Commission of Architectural Review

3. COA-179905-2026	Final Review Meeting Date: 2/24/2026
Applicant/Petitioner	Andy Scudder
Project Description	Revise previously approved plans for a rear two-story addition to include an enclosed porch
Project Location	
Address: 411 Chimborazo Boulevard	
Historic District: Chimborazo Park	
<p>High-Level Details:</p> <p>The applicant proposes the demolition of a small portion of a non-original rear addition and construction of a new two-story rear addition at the contributing single-family dwelling. The original structure dates to 1898 and has previously been altered with a pre-1925 rear addition and a more recent accessory dwelling unit. The proposed addition would sit within a recessed notch on the rear elevation and extend approximately 12 inches beyond the current footprint; the original house will remain unchanged except where the addition connects at the roof.</p> <p>The applicant is presently proposing an alteration to previously approved application, including altering the addition to be entirely enclosed, without a rear porch.</p>

Figure 1: June Proposal

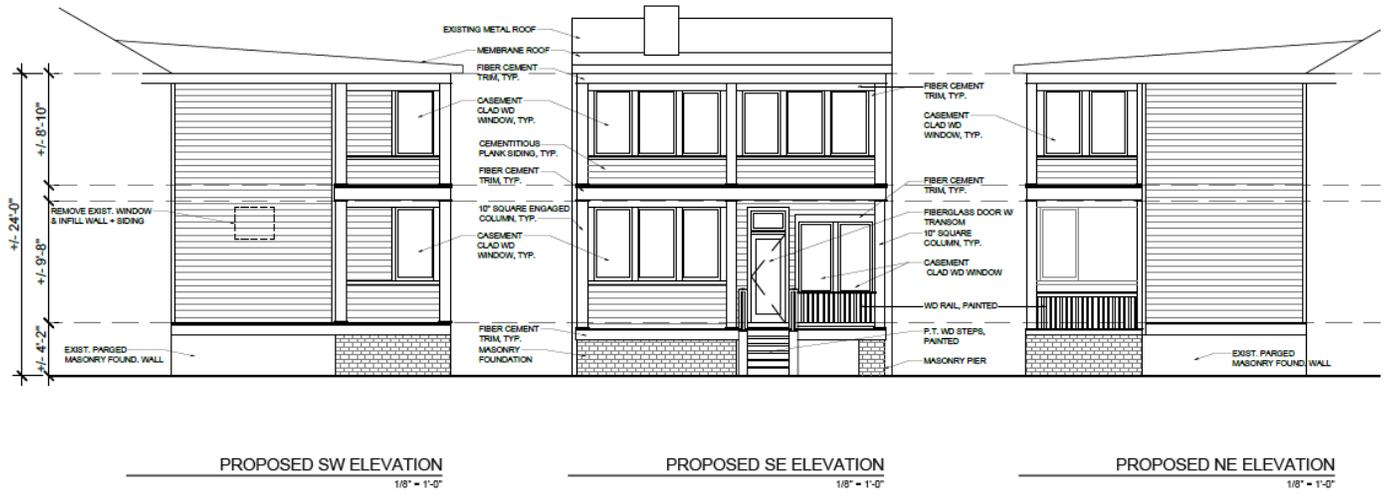
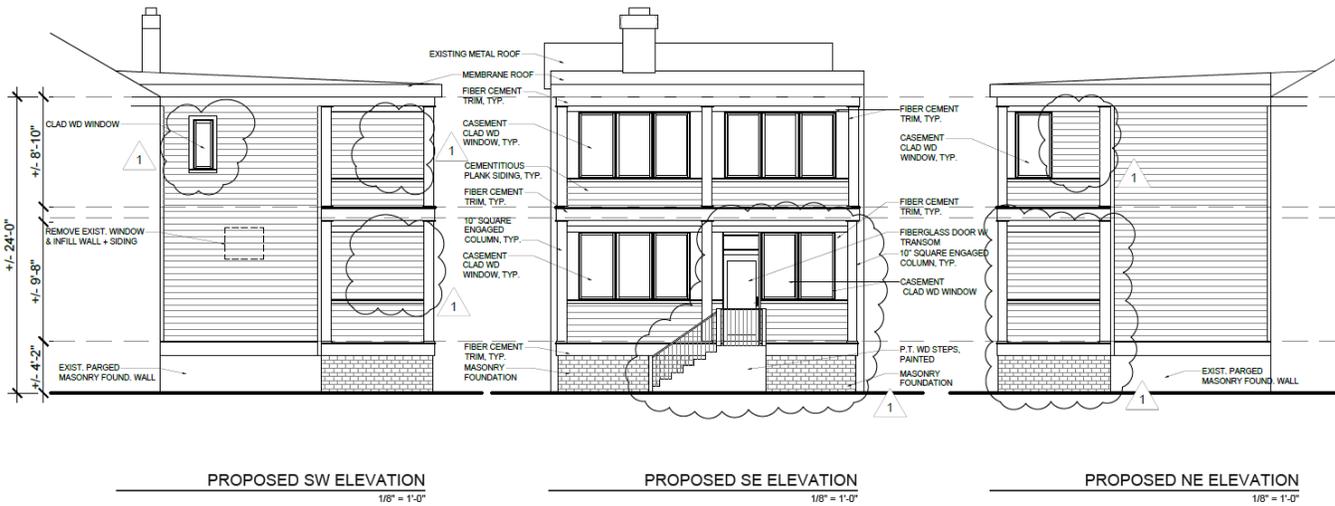
- In the June 2025 design, the addition incorporated exterior steps leading to an open porch. In the February 2026 revision, the porch area has been fully enclosed. The steps now lead directly to an entry door with a transom above, rather than to an open porch.

- On the southeast (rear) elevation, the right side of the first floor has been modified from an open porch with railing to a fully enclosed wall clad in siding. The second-story configuration on this elevation remains unchanged from the prior approval.

- On the southwest elevation, previously proposed windows on the right side of the first floor have been removed. A small window has been introduced on the left side. No other substantial changes are proposed for this elevation.

- On the northeast elevation, the first-floor porch with railings on the left side has been enclosed, consistent with the overall revision to the porch design. A previously proposed window in this location has been removed as part of the enclosure. On the second floor, the window arrangement has been modified to feature a single window in place of the previously approved double window configuration.

Staff Recommendations	<p>Staff recommends approving the revised proposal, with the following recommendations:</p> <ul style="list-style-type: none">• Staff finds that enclosing the porch does not significantly alter the previously approved design, nor does it diverge from the principles and analysis that guided the original approval.• Staff recommends approving the application with the previous conditions, as follows:<ul style="list-style-type: none">○ Approve the contemporary design of the rear addition, including the casement windows and low-slope roof form○ Applicant to submit Final color and material specifications for administrative review and approval.○ Demolition of non-contributing, previously altered elements to be done carefully and in a manner that minimizes damage to historic fabric.
-----------------------	---

Figure 3: June Proposal

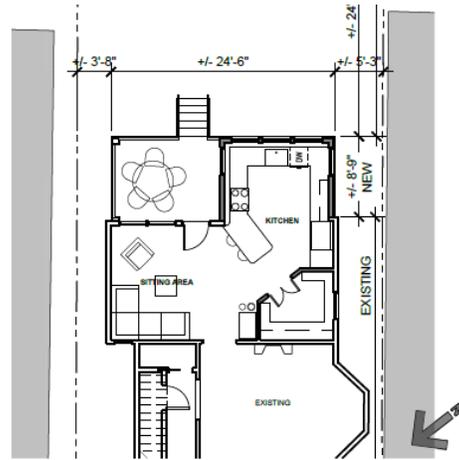
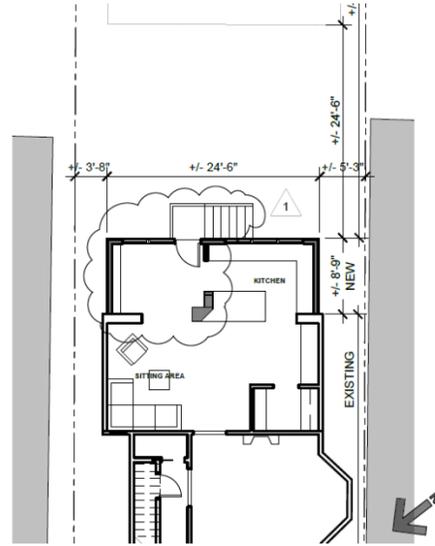
The primary revision to the proposal involves enclosing the previously approved first-floor porch within the rear addition.
